Mason Dam Hydroelectric Project
FERC No. P-12686

RE: ODEQ Comments to the DO Compliance Plan (October 2010)
Mason Dam Hydroelectric Project (FERC No. P-12686)

Subject: ODFW's Comments on Baker County's draft plans for the proposed Mason Dam Hydroelectric Project (FERC No. 12686).

Attachment 7.1

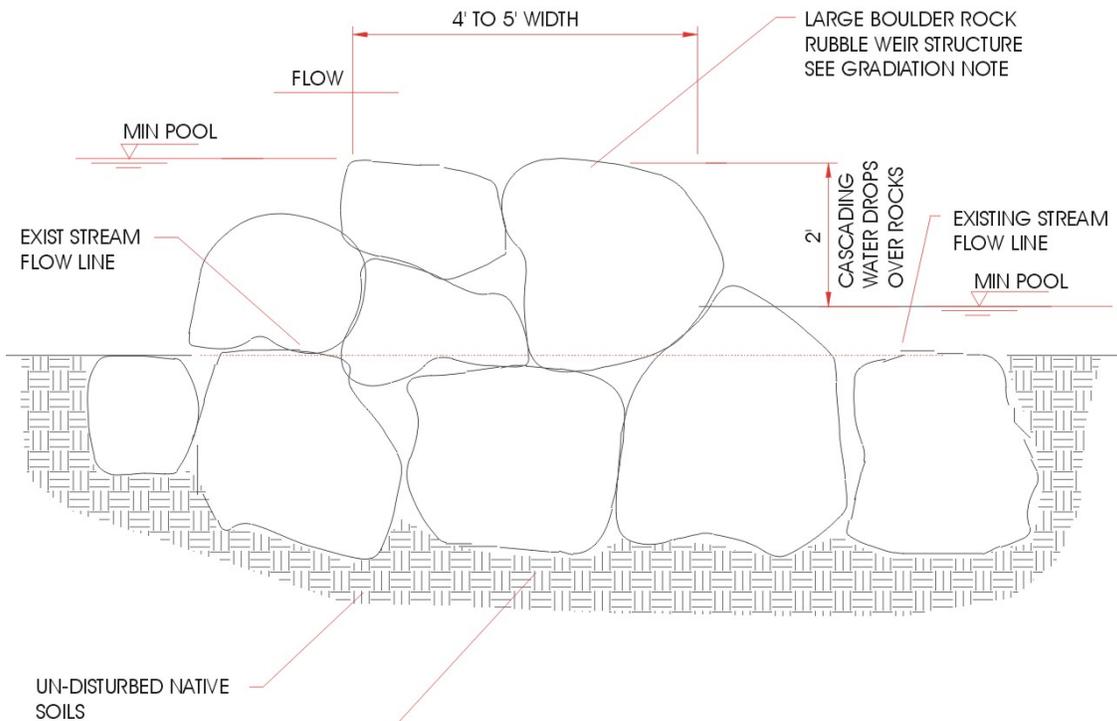
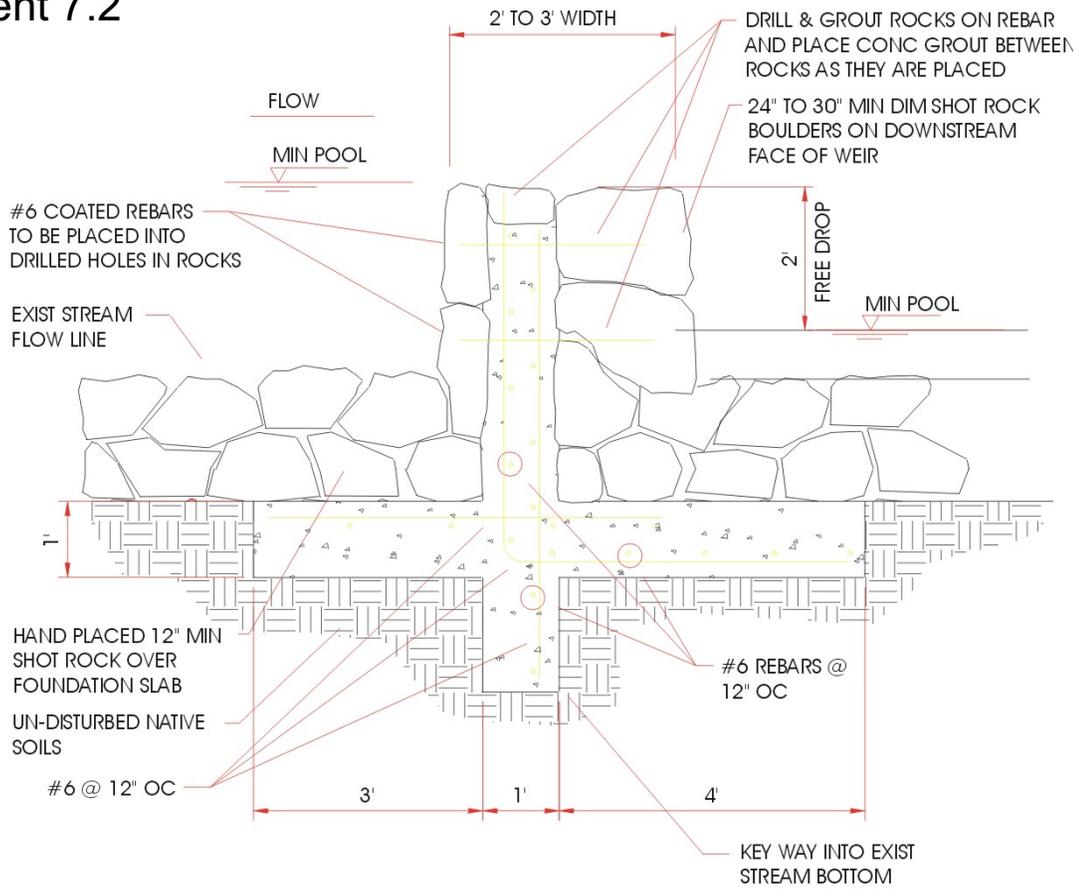
5.1.2.5 – ODFW believes that state water quality standard for DO will need to be met at the downstream end of the stilling basin. According to Attachment 7.1, however, three rock weirs would be placed within the 0.16 mile section of the Powder River downstream of the stilling basin. Therefore, the state standard for DO would not be met at the downstream end of the stilling basin. If DO standards cannot be met at the downstream end of the stilling basin with installation of rock weirs, ODFW recommends that other alternatives be investigated that would provide a reasonable assurance of compliance with state water quality standards. Further, how were locations and numbers of weirs determined?
